SUNDRY NOTICES AND REPORTS ON WELLS

MACK ENERGY CORPORATION

DREWERY FEDERAL #2
SEC6 T17S R30E 1650FNL 1980FWL

MACK ENERGY CORPORATION
 WELL DIAGRAM
 DREWERY FEDERAL #2
 SEC 6 T17S R30E
 1650FNL 1980FWL

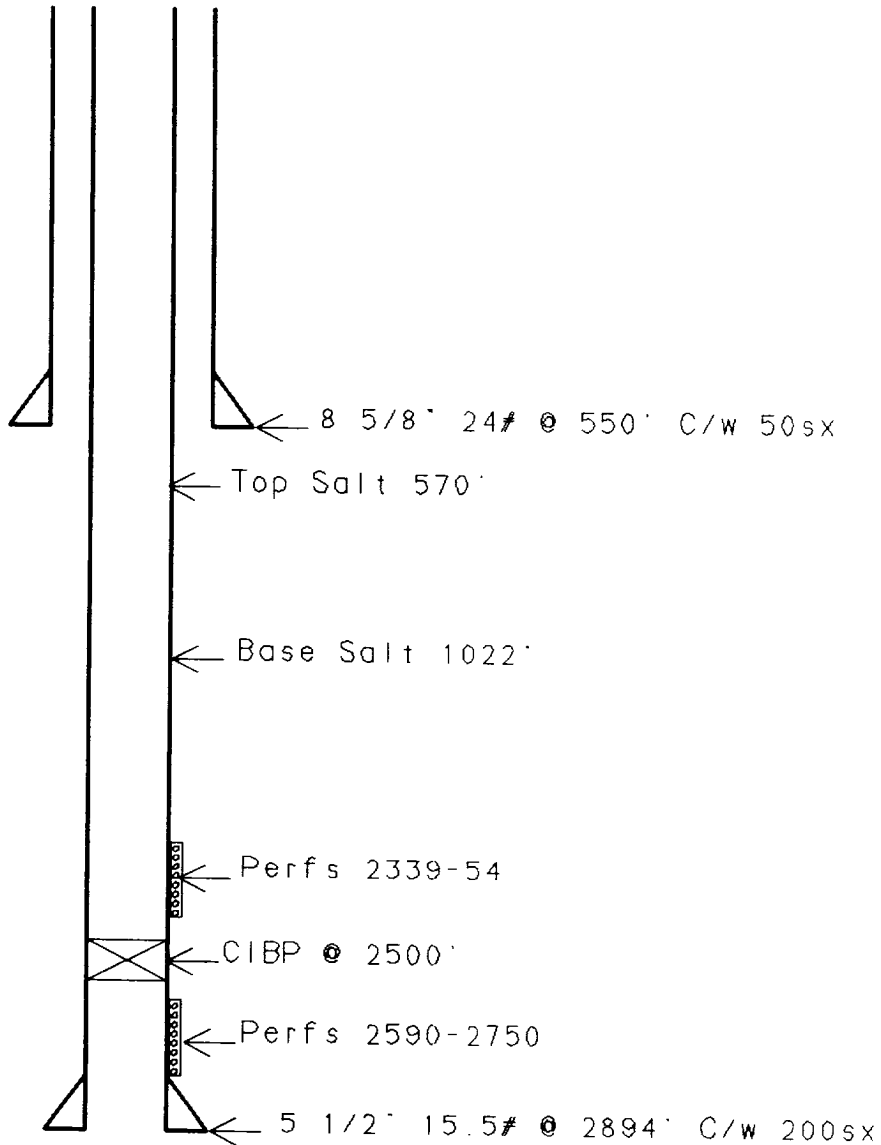
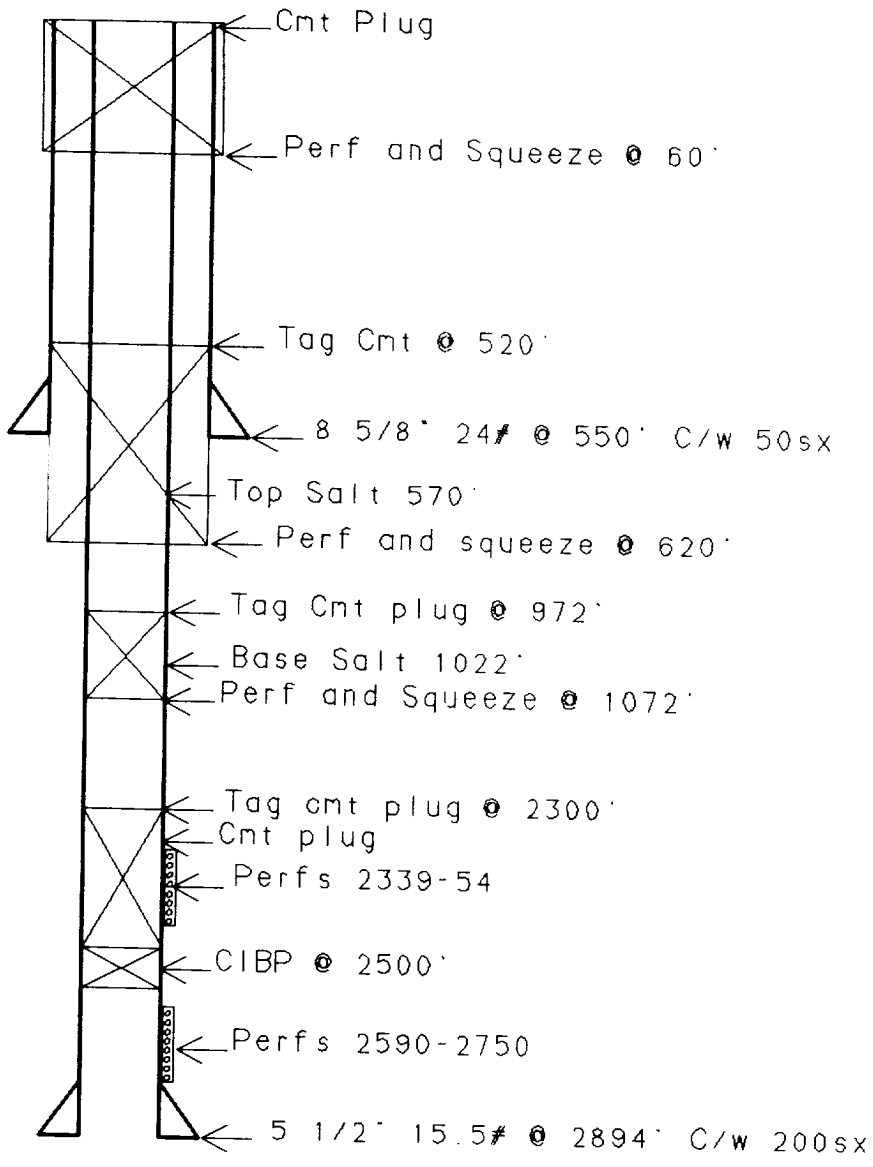
Conditions of approval, if any: See attached. Step # 7: perf csg 50' below 8 5/8" shoe (600') & tag plug @ 500'
